Sent: 9/07/2020 10:25:04 AM
Subject: 41-43 Beach Road Collaroy NSW 2097 DA 2019/1522 WRITTEN
SUBMISSION BUCKLE & DORSEN
Attachments: 41 Beach 090720.pdf;

DA 2019/1522

WRITTEN SUBMISSION: LETTER OF OBJECTION

Submission #4: Buckle & Dorsen

Figure 2 – Cross section view of master bedroom height encroachment

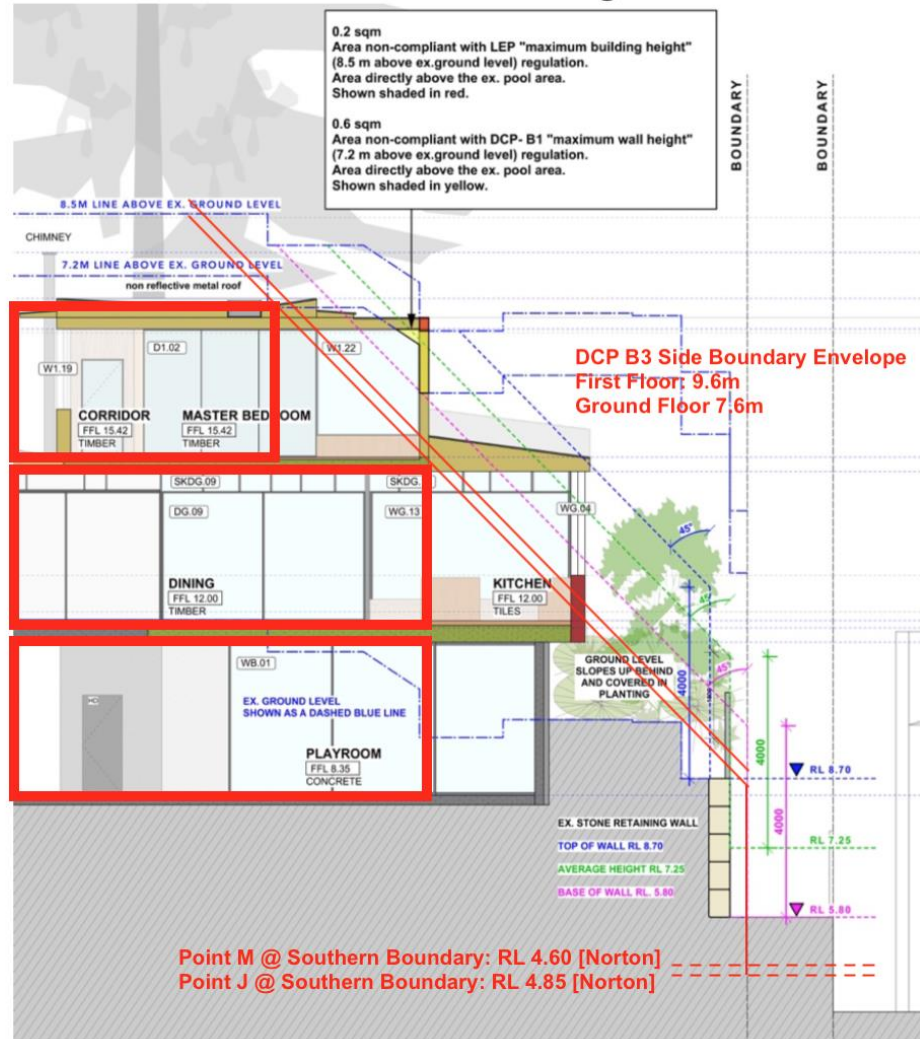
The sectional drawing on page 3 of the Clause 4.6 Application is incomplete and misleading. The author of the Clause 4.6 Application should have assessed that this section on page 3 does not consider the correct levels at Point J or M, and if he had done so, the author of the Clause 4.6 would have clearly identified a massive 223% non-compliance to the very important **DCP B3 Side Boundary Envelope** control.

The Clause 4.6 Application does not make a case for the rampant non-compliance, and fails to identify the false and misleading drawing that was relied upon within the Clause 4.6 application.

DA Sectional Drawing from Clause 4.6: Levels at Point J @ RL 4.85 and & Point M @ RL 4.60 not shown. Required setback to accord with DCP B3 Side Boundary Envelope shown in red block massing. Ground Floor 7.6m setback, First Floor 9.6m setback.

We are concerned that this drawing does not form part of the substituted drawings on Council website, and we have had to locate this misrepresentation within the Clause 4.6 Application. Why the Applicant has not presented this drawing within the substituted drawings for all neighbours to assess, is troubling?

We ask Council to ensure that this DA section drawing is corrected with the actual boundary levels at Point J & M properly shown at RL 4.60 and RL 4.85, with the DCP B3 Side Boundary Envelope properly shown, and this drawing resubmitted.

We ask Council to request that the Applicant shows the NSWLEC 1189 Stamford Property Services Pty Ltd v City of Sydney ground levels as presented within this Submission, particularly from Point M & J.
